SURRY POWER STATION, UNIT NO. 1

Amendment No. 53  
License No. DPR-32

Amendment No. 52  
License No. DPR-37

ATTACHMENT TO LICENSE AMENDMENT NOS. 53 AND 52

VIRGINIA ELECTRIC AND POWER COMPANY  
 ORGANIZATION CHART  
 POWER OPERATIONS

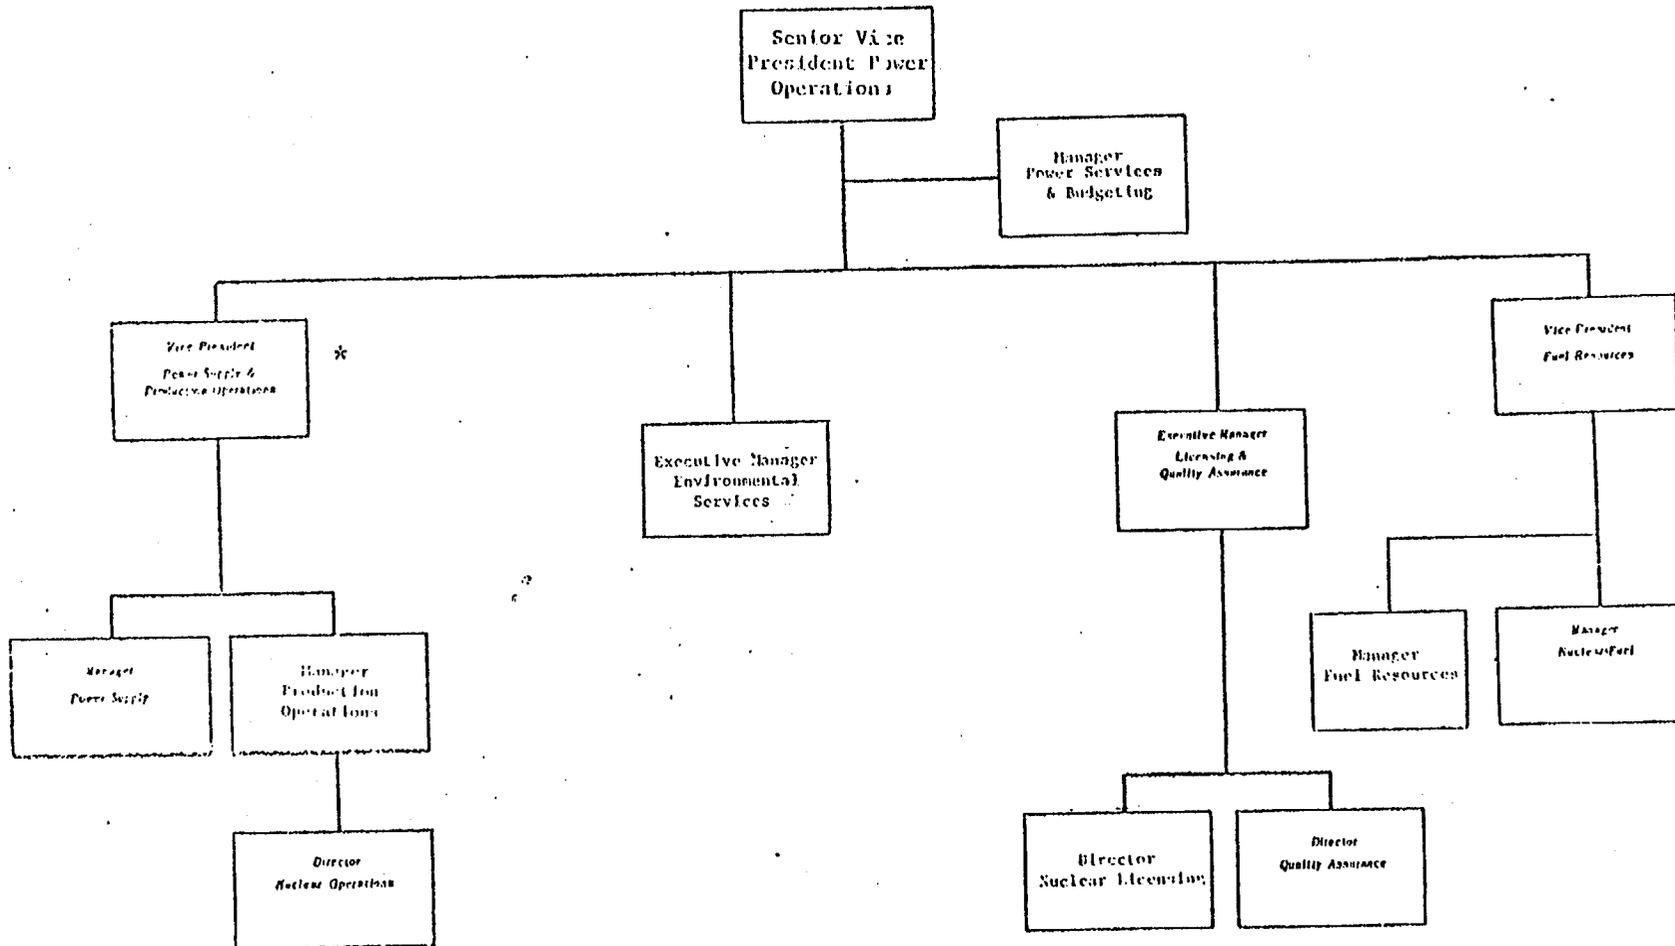
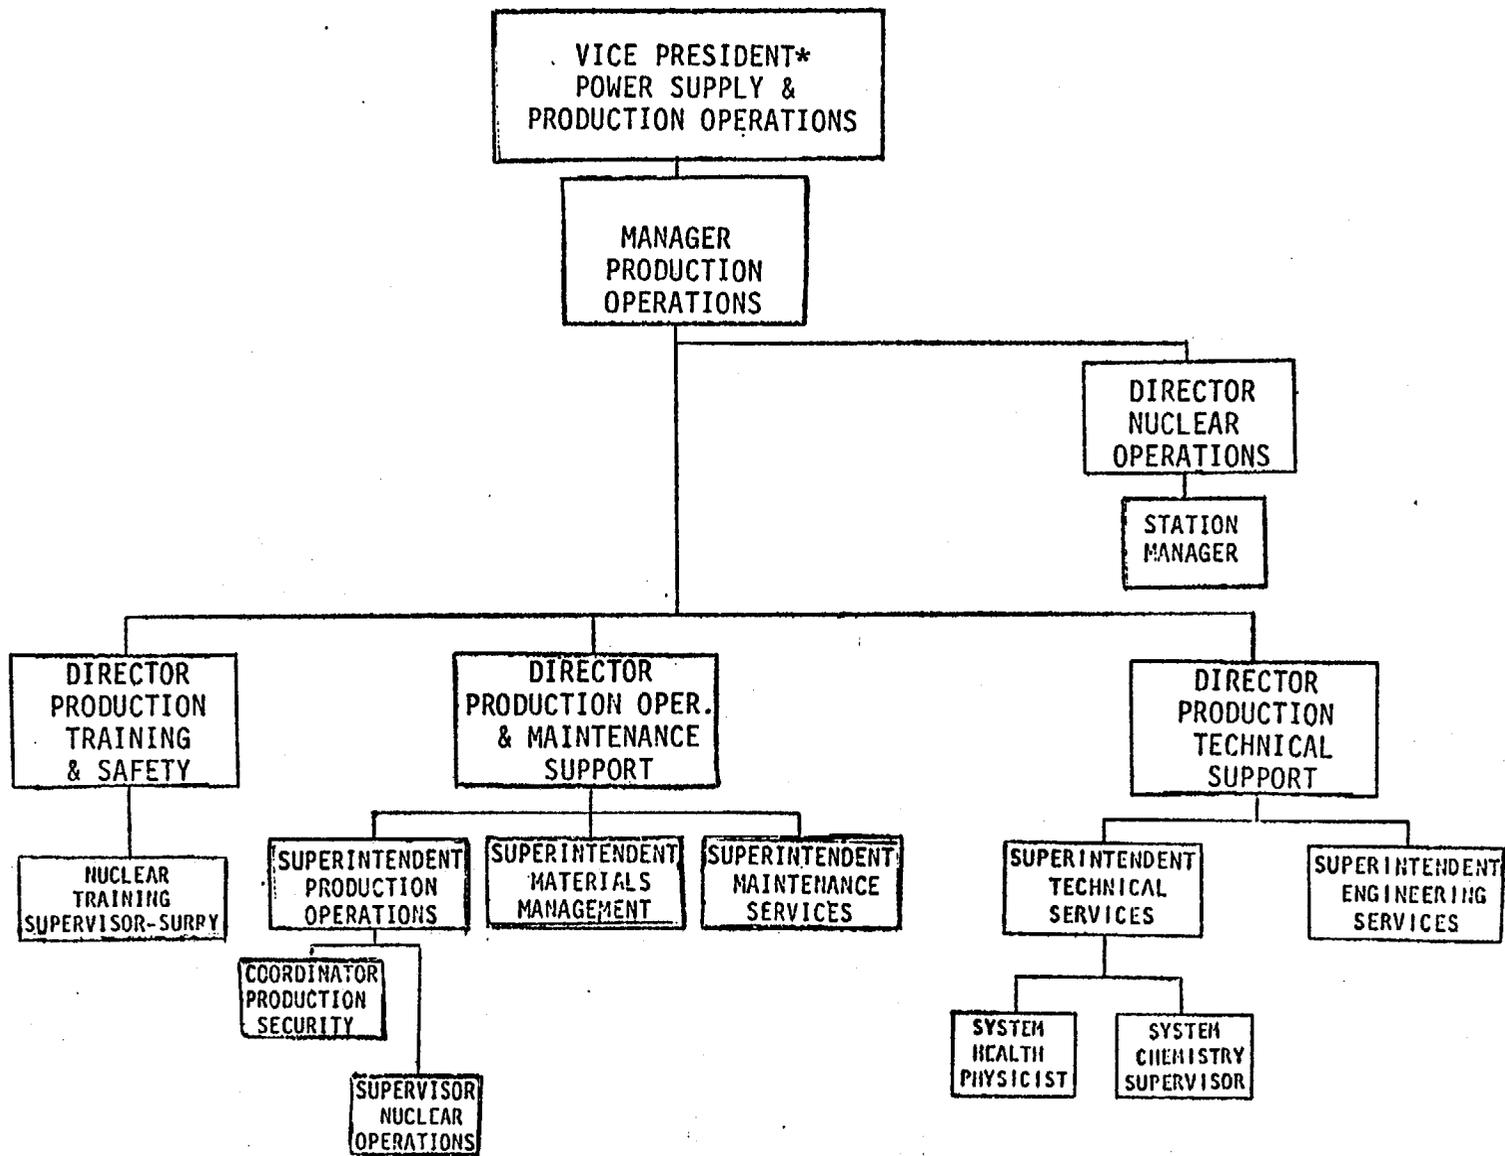
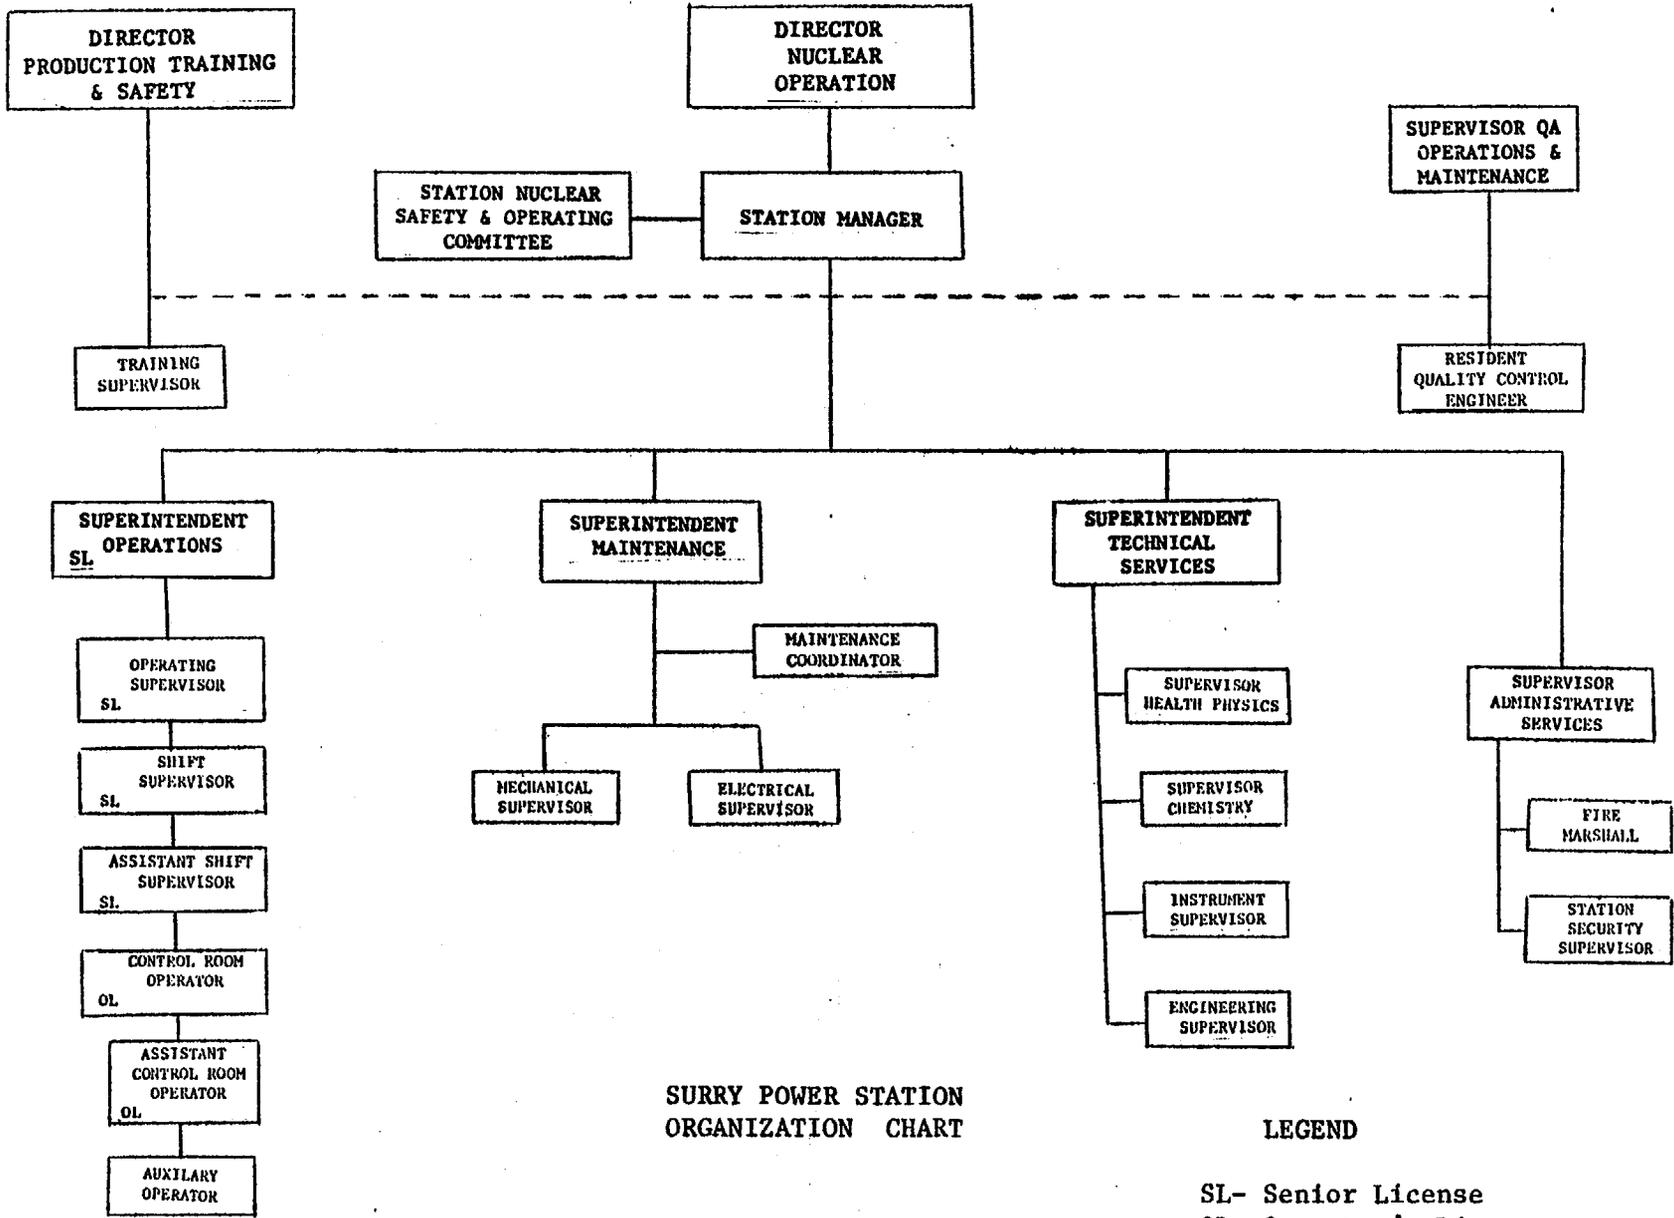
The amendments revise the Technical Specifications to (1) reflect reorganization of the Production Operations Department onsite and offsite, (2) delete reference to the respiratory protection equipment since this item is now covered by 10 CFR 20.103 of the Commission's regulations, (3) increase the fire brigade training and drill interval to 92 days, and (4) incorporate several minor clarifications and typographical corrections.

- A. The Station Manager shall be responsible for the safe operation of the facility. The Station Manager shall report to the Director-Nuclear Operations. The relationship between this Director and other levels of company management is shown in TS Figures 6.1-1 and 6.1-2.
- B. The Station organization shall conform to the chart as shown in TS Figure 6.1-3.
  1. Each member of the facility staff shall meet or exceed the minimum qualifications of ANSI N.18.1-1971 for comparable positions, except for the Supervisor-Health Physics who shall meet or exceed the qualifications of Regulatory Guide 1.8, September 1975.

We have found that the reorganization of the Production Operations Department onsite and offsite is administrative in nature and, as such, does not decrease the overall effectiveness of that department. This change conforms to our current guidance and is acceptable. The minor clarifications and typographical corrections do not change the intent of the Technical Specifications and therefore, are acceptable.
